FROM: Department of Purchasing and Contracting, DeKalb County, Georgia

ADDENDUM NO. 2

Invitation to Bid (ITB) No. 21-101473 – 2022 Gas Collection and Control System (GCCS) Expansion at Seminole Road MSW Landfill, is hereby amended as follows:

OVERALL SITE TOPO AND AERIAL FIGURE

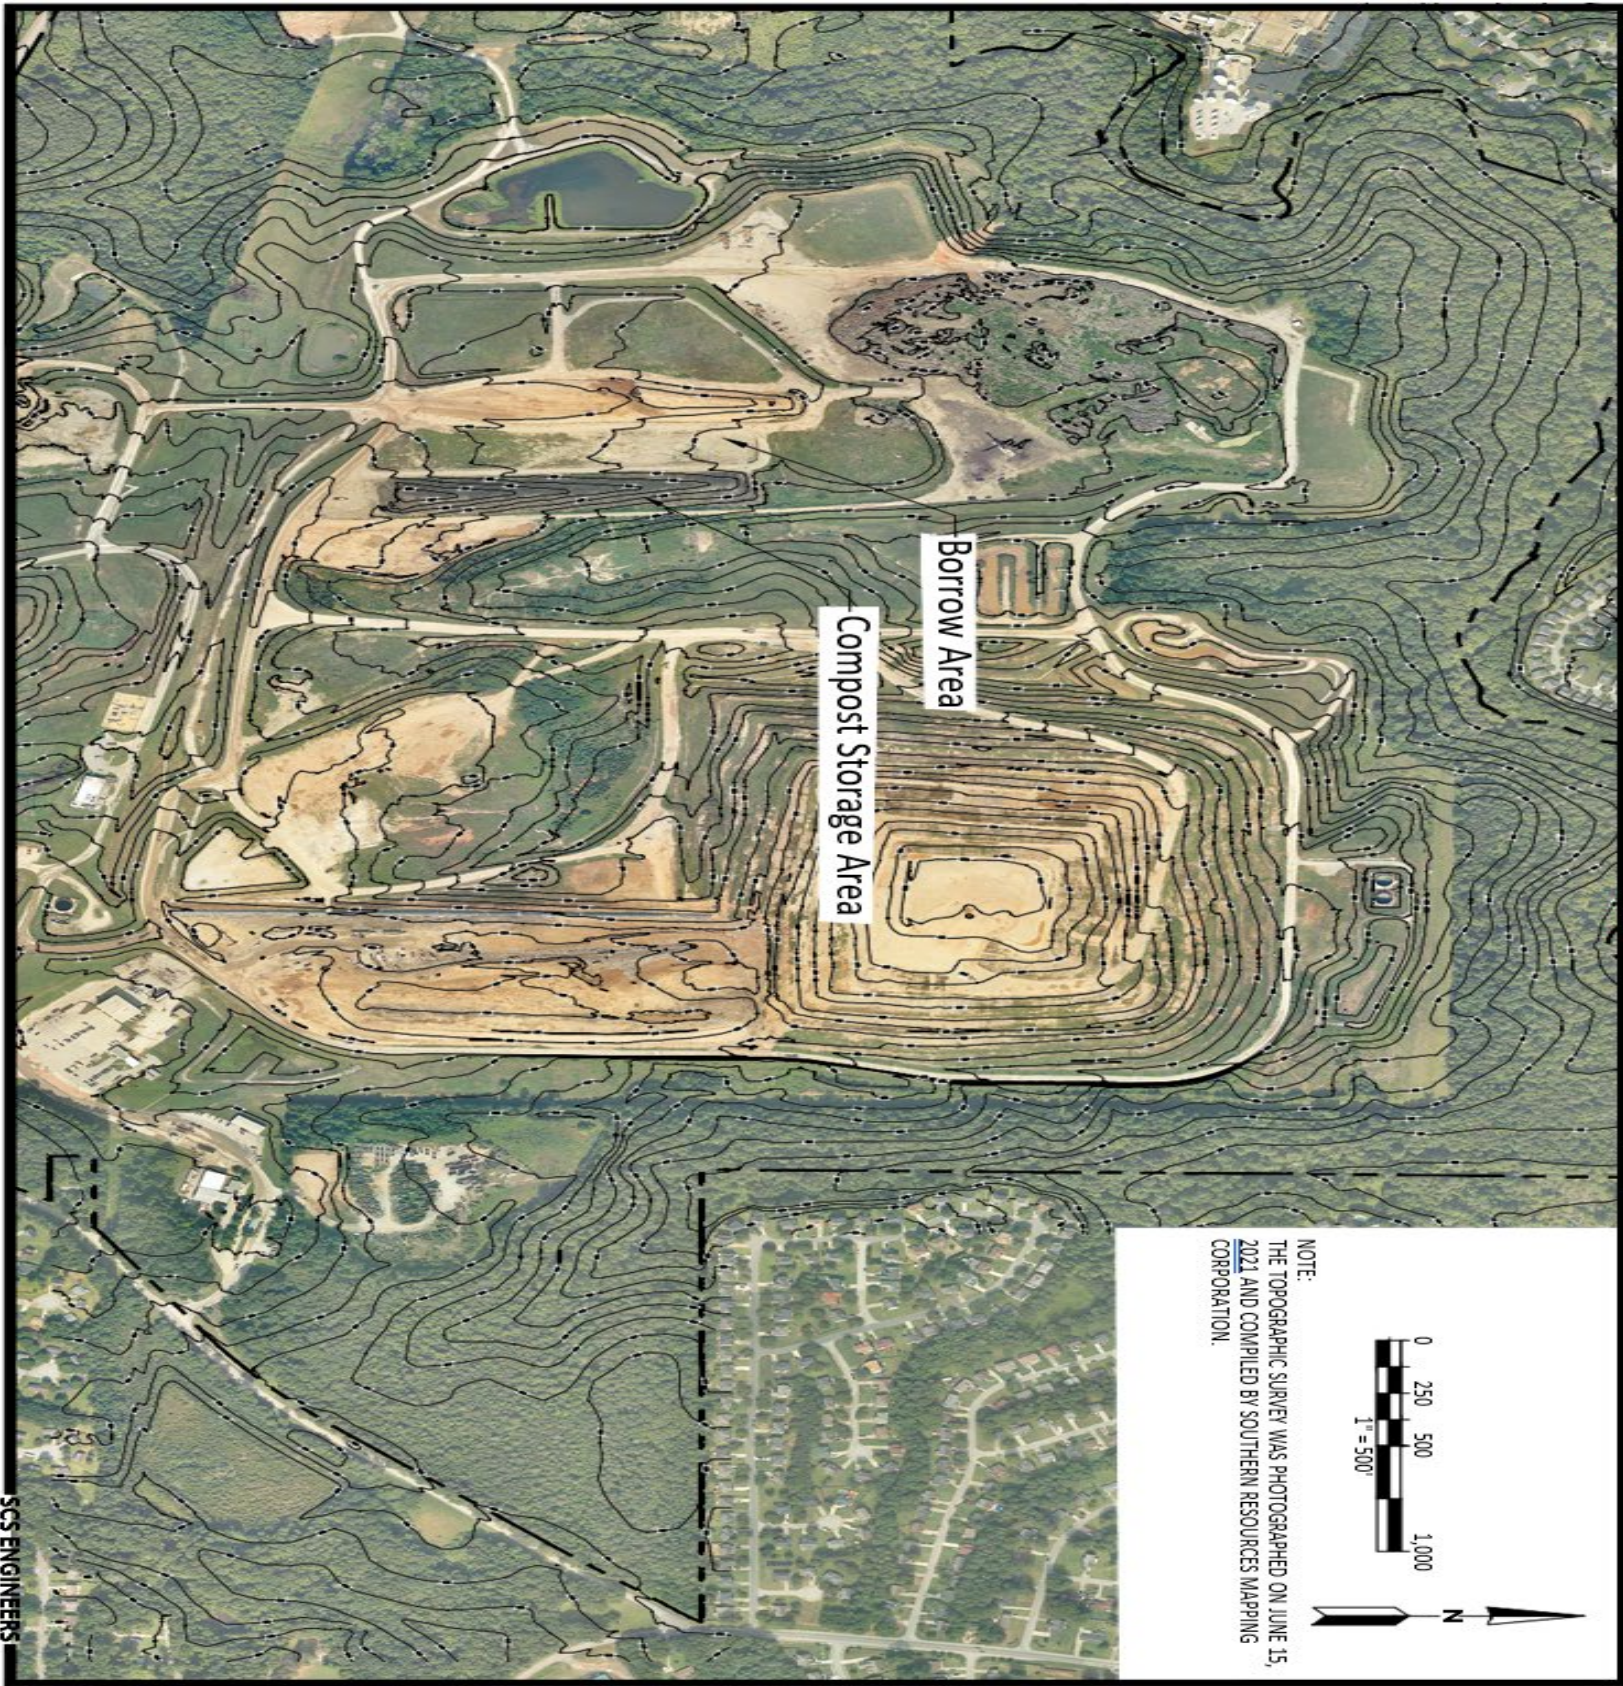
Question 3: Does the landfill have a clean backfill material that the contractor can utilize as backfill for pipeline trenches? Where is the borrow pit located? Please confirm that the contractor should not count on the county personnel to load the contractor's trucks with backfill soils.

- Question 24:** Where is the borrow soil pit?
- Response:** See Response to question 3, as well as **OVERALL SITE TOPO AND AERIAL** figure below for the location.

Response: **Yes, the landfill has clean back fill material on site. The borrow area is located directly west of our long-term compost storage area, and it's a short distance from the purposed construction area. Please see attached figure for the location. Our landfill operators will not be responsible for loading/ unloading or hauling of any material for the contractor. The contractor should have all the necessary equipment to be self-sufficient at all times.**
